## **VIRGINIA STREET SUBDIVISION**

APPLICATION NUMBER 28 DATE April 21, 2005  
APPLICANT Virginia Street Subdivision  
REQUEST Subdivision

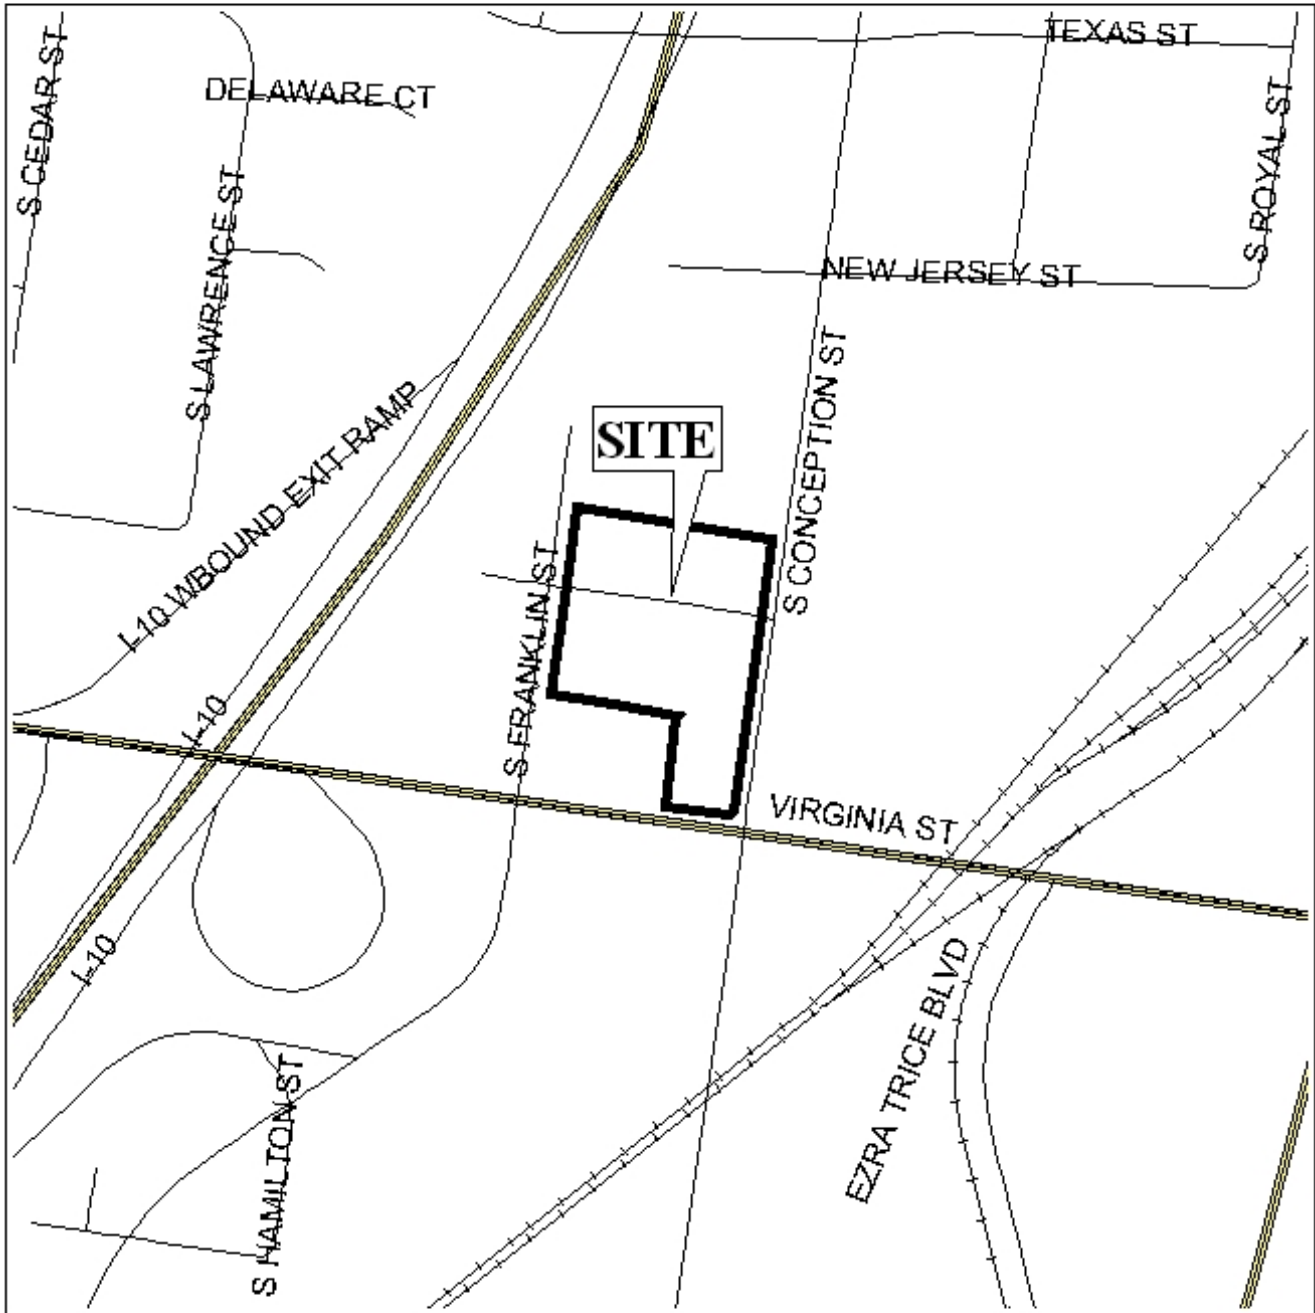
The site fronts Franklin Street, Virginia Street, and Conception Street, all of which have 50' wide rights-of-way. However, Virginia Street is shown as a major street on the Major Street Plan and as such requires a 100' right of way; thus dedication of sufficient right-of-way to provide 50' from the centerline of Virginia Street should be required. As a means of access management, Lot 1 should be limited to one curb cut to Virginia Street. It should be noted that the portion of Maryland that formerly intersected the site has been vacated, and there is a 25' ingress and egress easement within the former right-of-way.

The 25' building setback line is not shown, but would be required on the final plat.

The plat meets the minimum requirements of the Subdivision Regulations and is recommended for Tentative Approval, subject to the following conditions: 1) the dedication of sufficient right-of-way to provide 50' from the centerline of Virginia Street; 2) the placement of a note on the final plat stating that Lot 1 is limited to one curb cut to Virginia Street, size, location, and design to be approved by Traffic Engineering; and 3) the depiction of the 25' building setback lines on the final plat.
